## MEETING MINUTES

<b>PROJECT:</b> Water Treatment Plant	<b>PAGE:</b> 1 of 2
<b>OWNER:</b> City of Long Beach	<b>PROJECT NUMBER:</b> 08856
<b>MEETING DATE:</b> 9/28/10	<b>CONTRACTOR:</b> Rotschy, Inc.

**CITY OF LONG BEACH**  
**WATER TREATMENT PLANT**  
**PIPE TRENCH GRATING EXHIBIT**

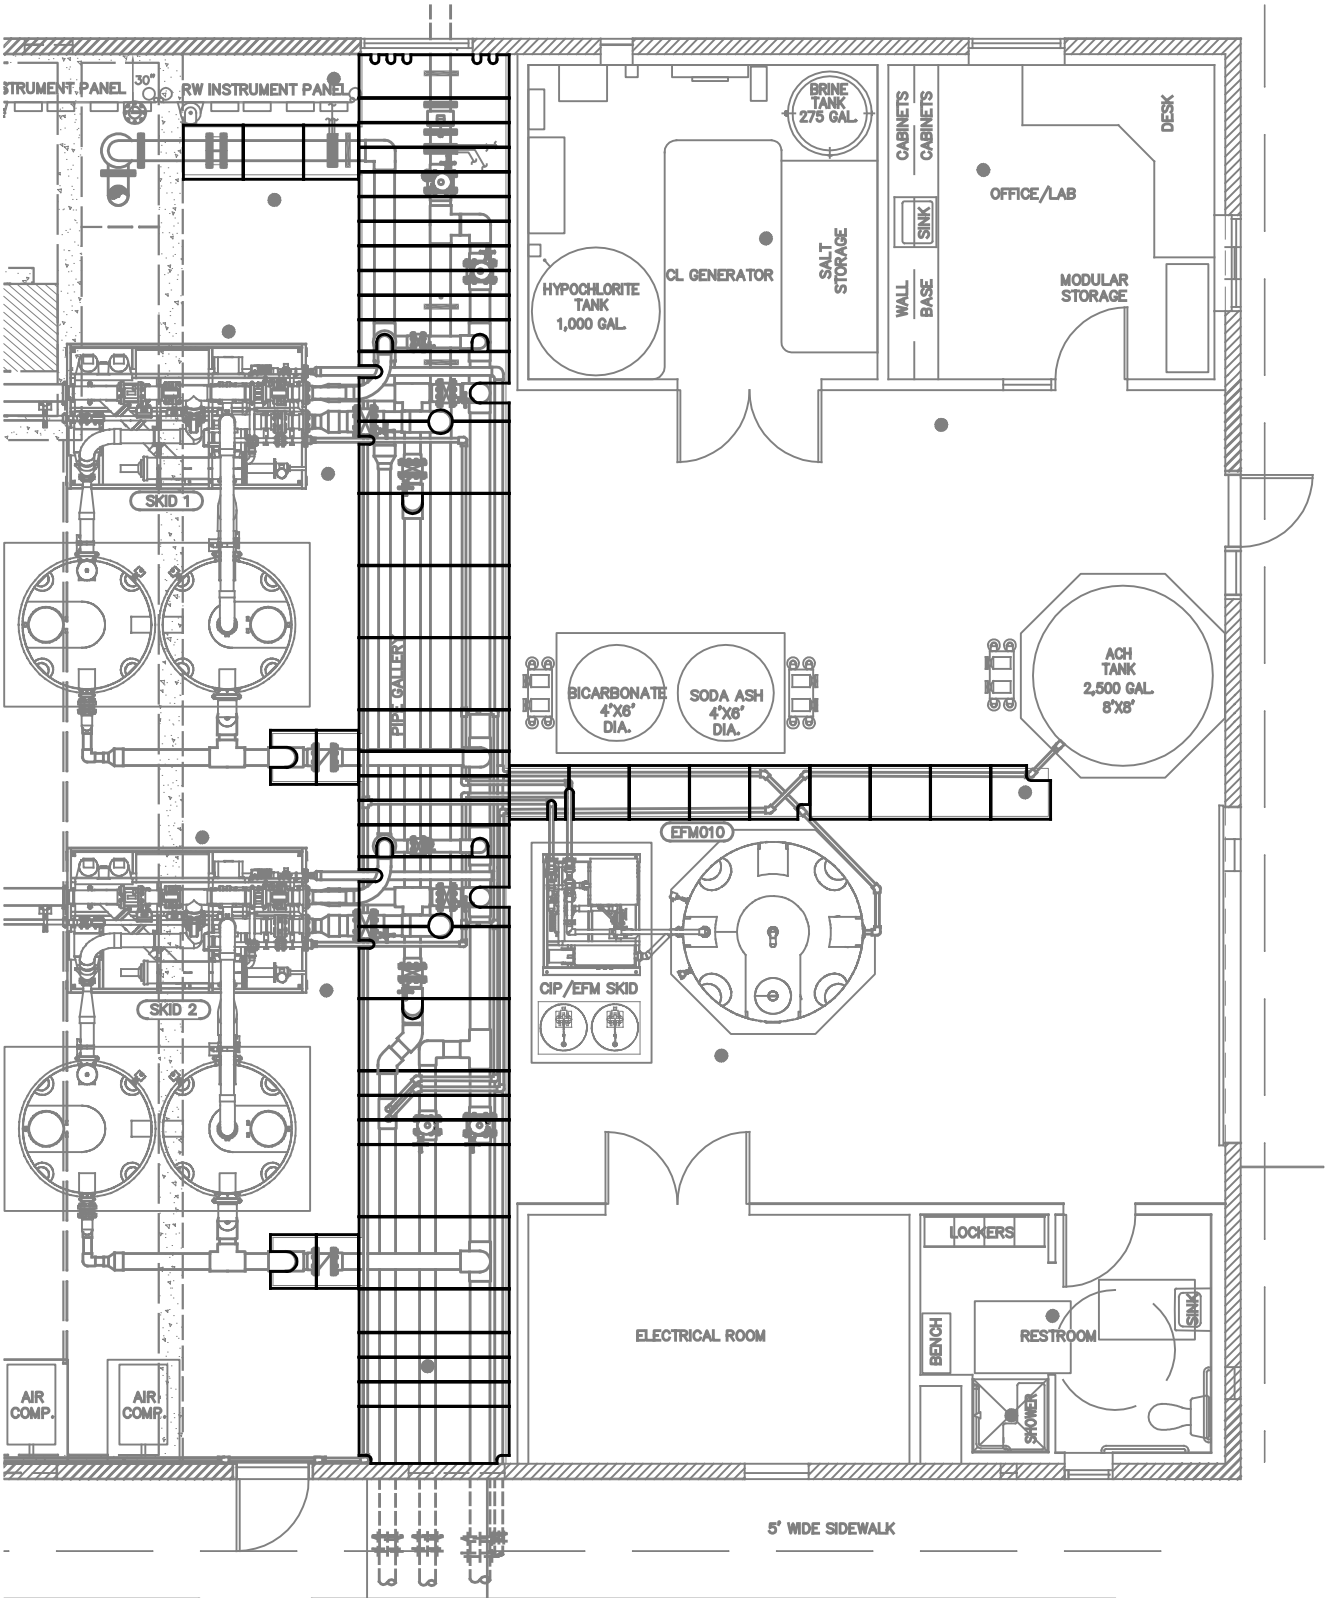
- The pipe trench layout and pipe trench grating were discussed. All parties agreed upon the revised pipe trench piping and grating layouts provided by PACE on the attached exhibits. PACE will forward the grating layout to the grating manufacturer in CAD.
